CONSTRUCTION BULLETIN

CHIPOTLE MEXICAN GRILL

C.B. # 1

Project: *Springfield TN, Store #5330*

1 / A130 **FURNITURE, FIXTURE & EQUIPMENT PLAN**
1/4" = 1'-0"

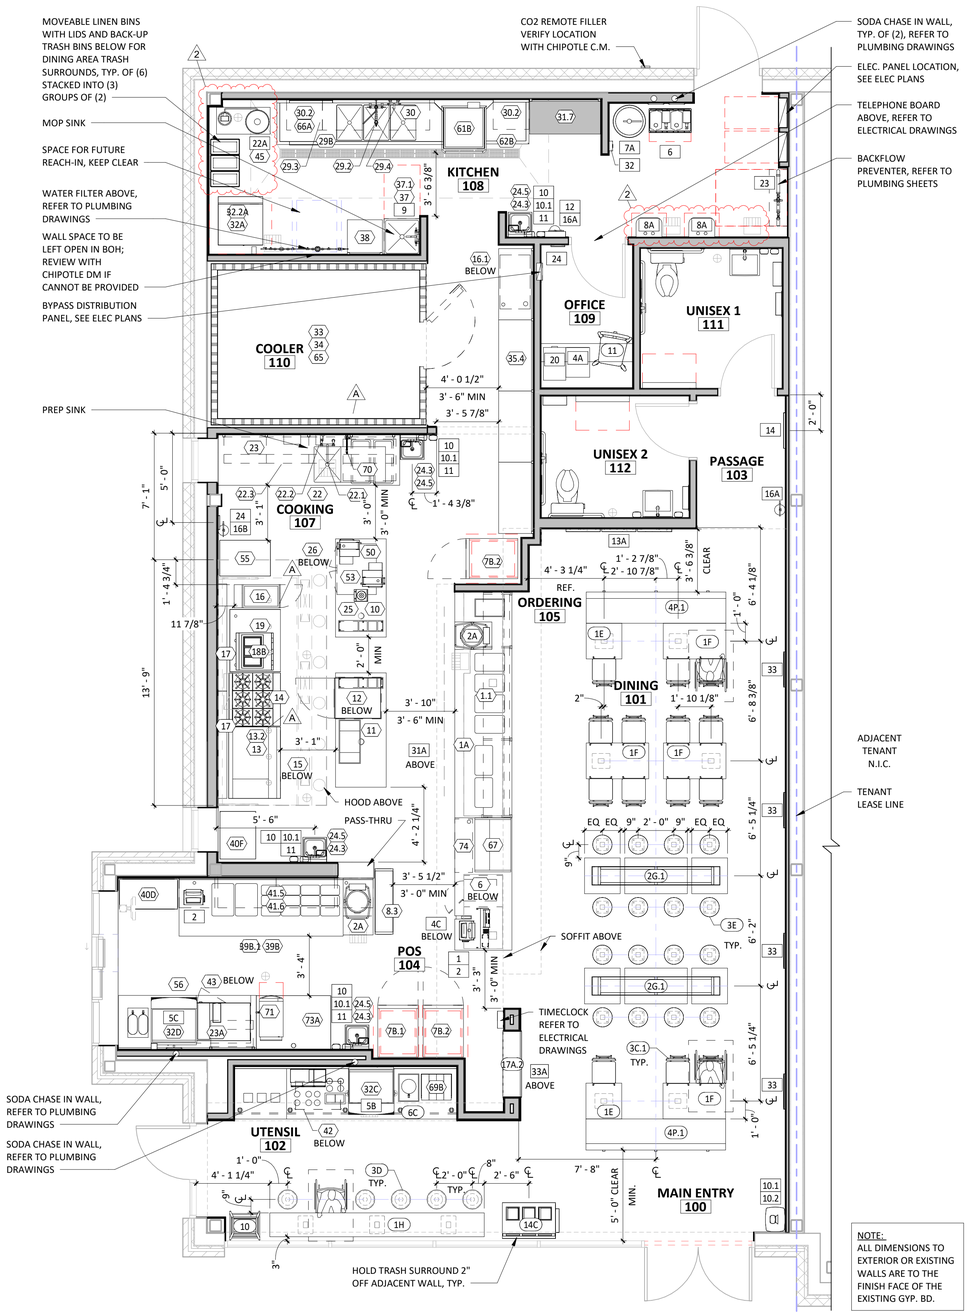
Sheets: A120, A130, 131. A702, S100, P100, P110
Shifted water softener to rear corner of kitchen and re-spaced the water heaters, removed corresponding concrete curb and added a dunnage rack at new location. Modified plumbing and electrical accordingly, including new floor drain in the back corner at the softener and additional floor sink at new water heater locations.

2 A201 **DIMENSIONED REFLECTED CEILING PLAN**
1/4" = 1'-0"

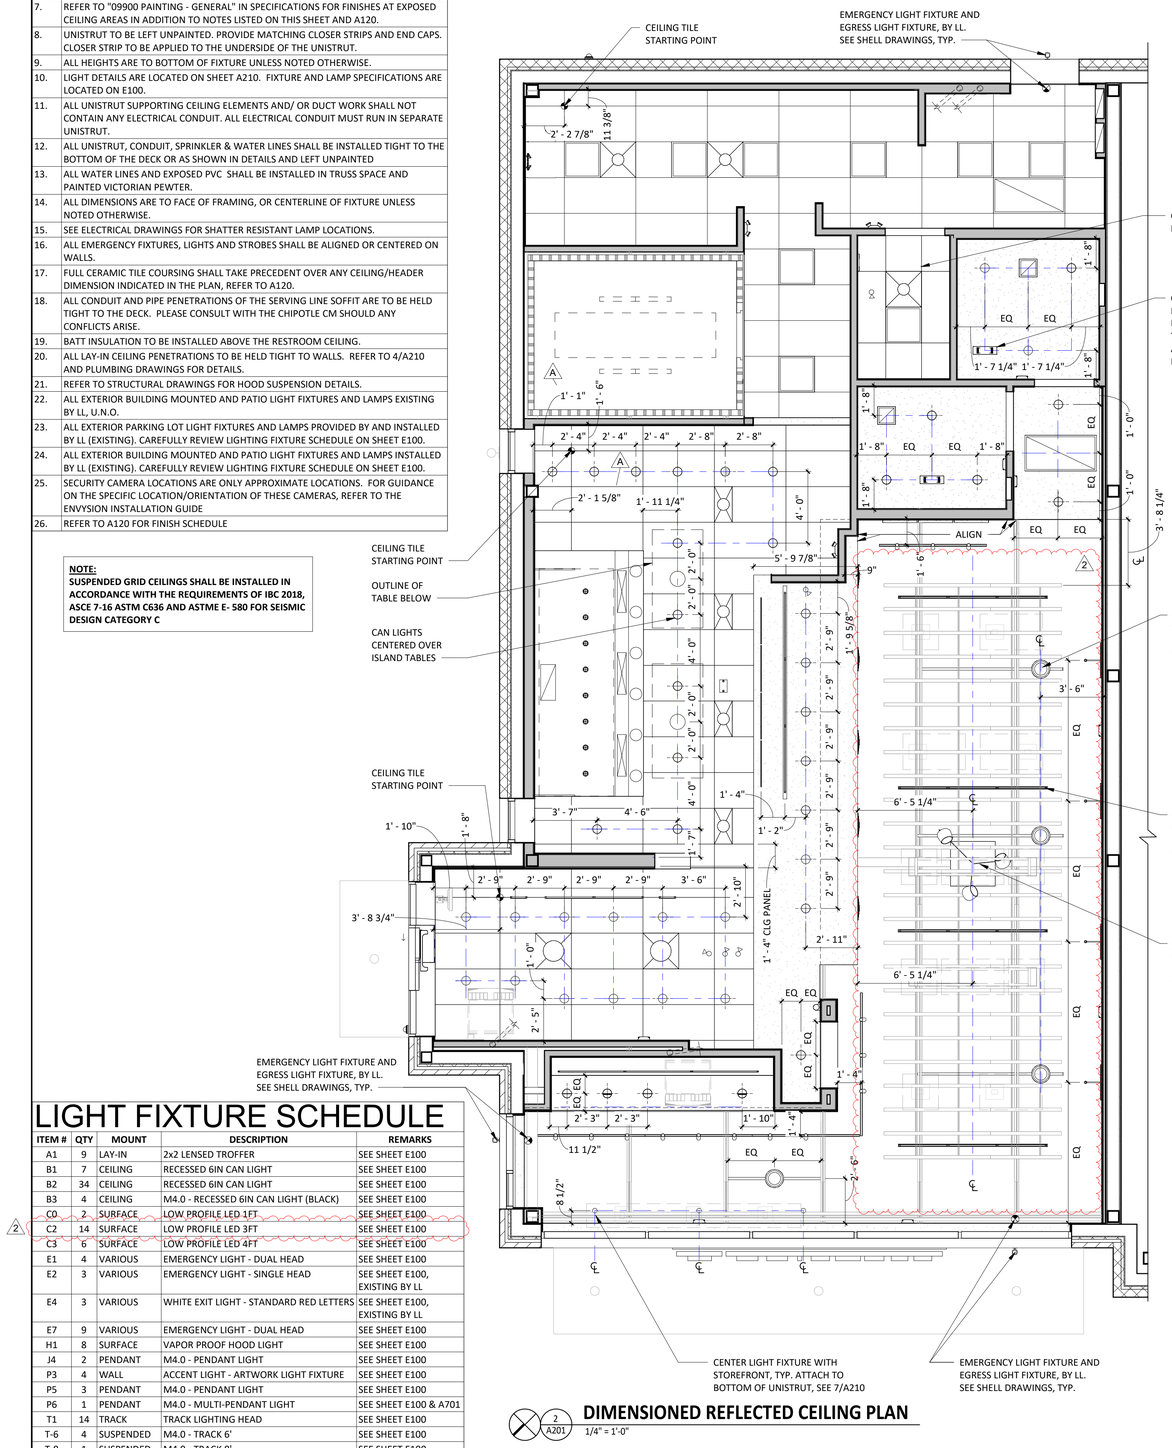
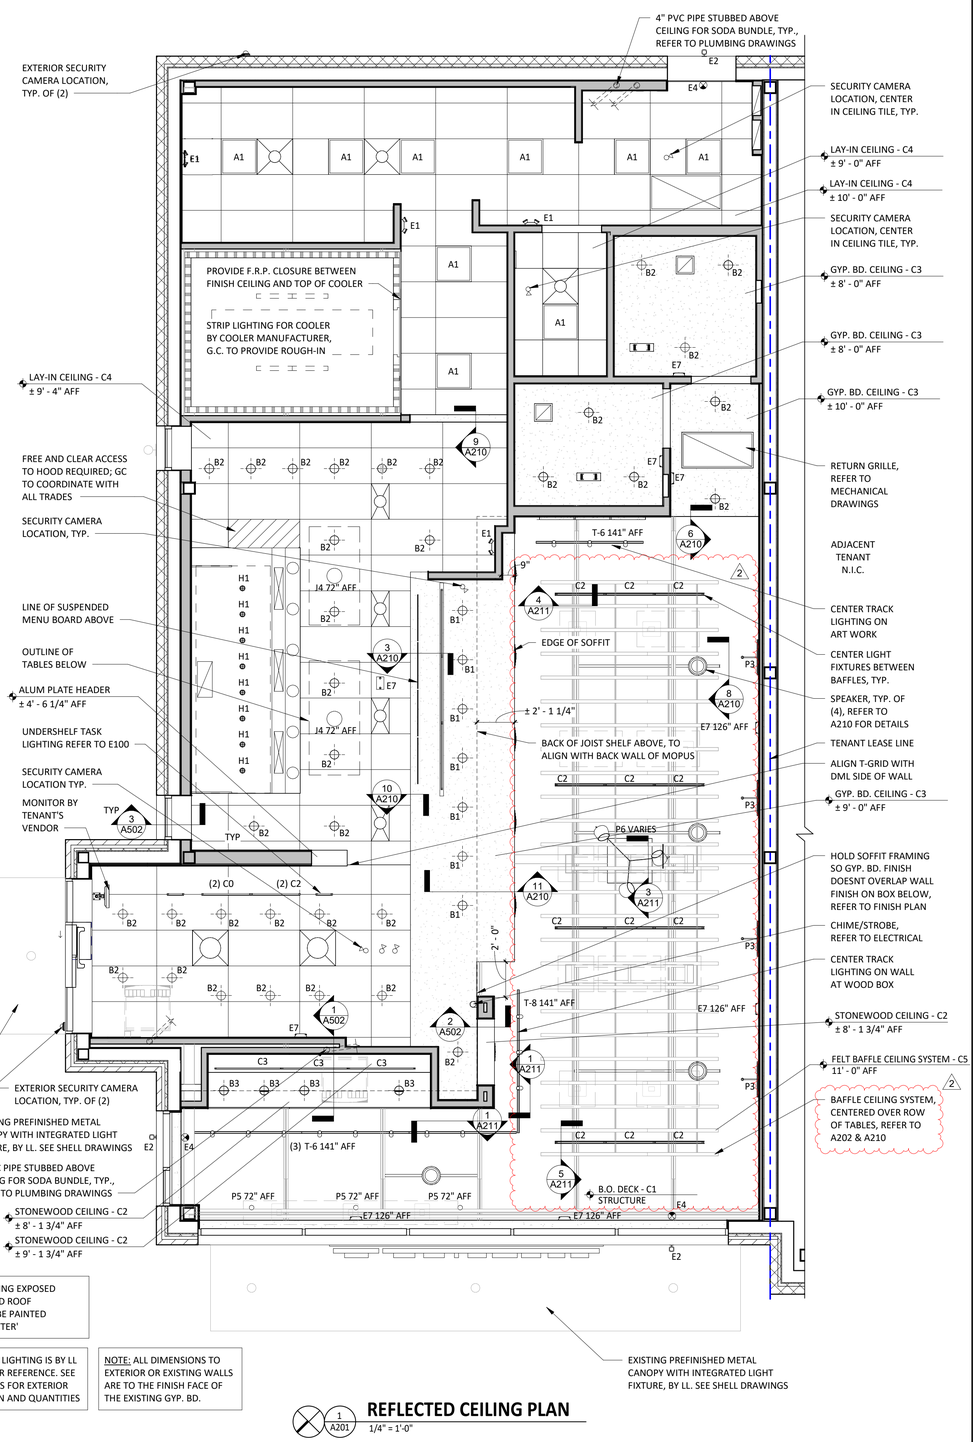
Sheets: A201, A202, A701, E100, E600
Revised extents of felt baffles and linear light fixtures in the Dining Room ceiling. Baffles are now

10'-0" wide and (3) linear fixtures creates a 9'-0" run of lights at each location.

1 E110 **POWER FLOOR PLAN**
1/4" = 1'-0"

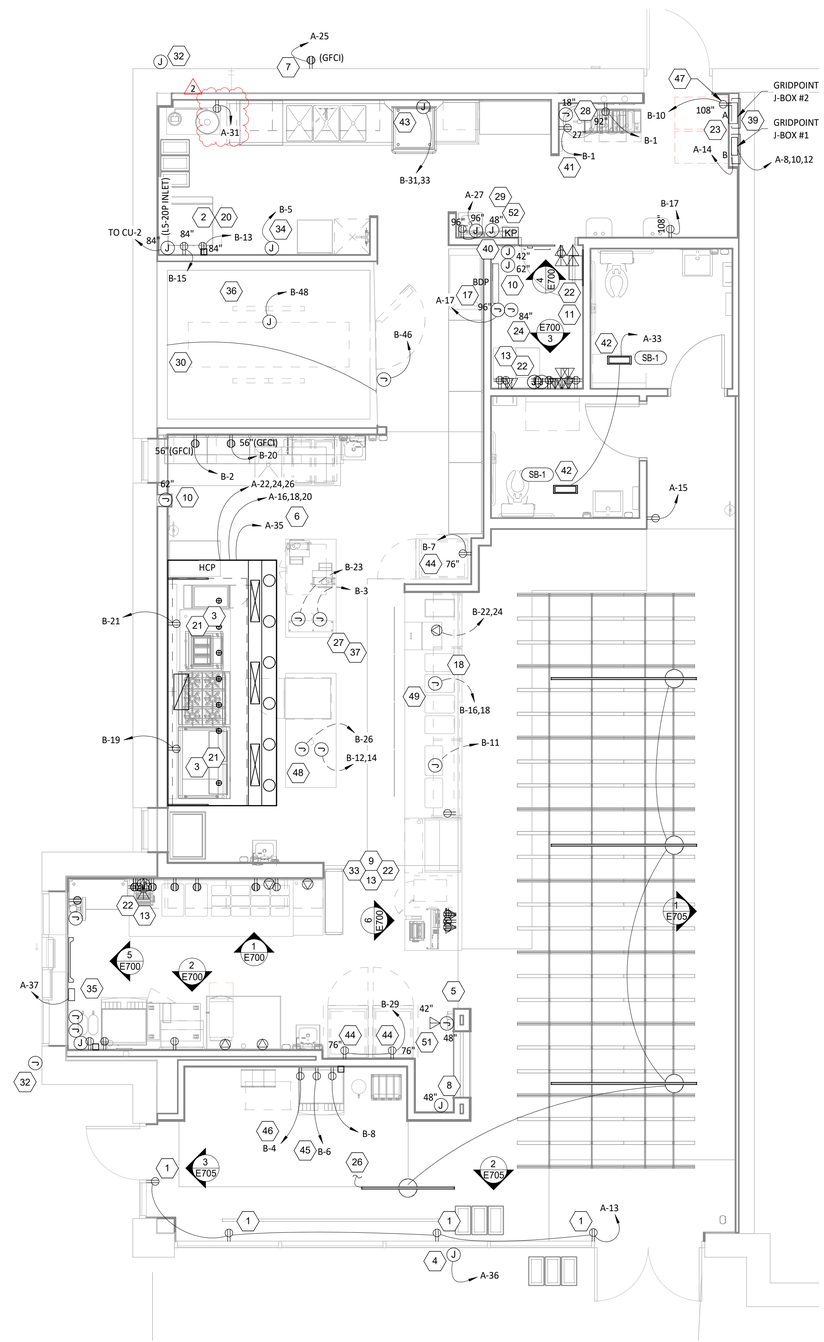
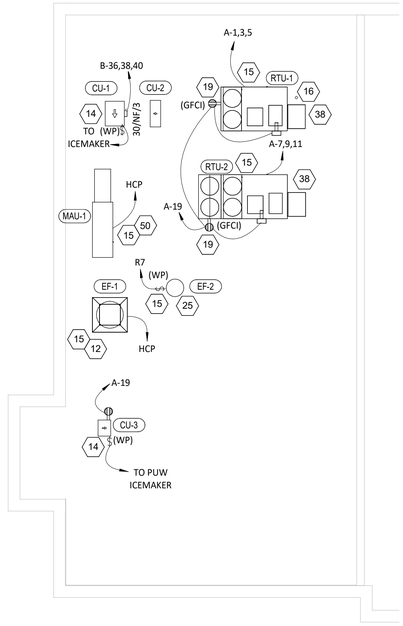
#4	Revision		Per Direction of: *Design Bulletin*
	Correction	**X**	
CHANGES MADE : SHEETS AFFECTED			
Sheets: E110 *Edited coded note #5 based on previous design bulletins.*
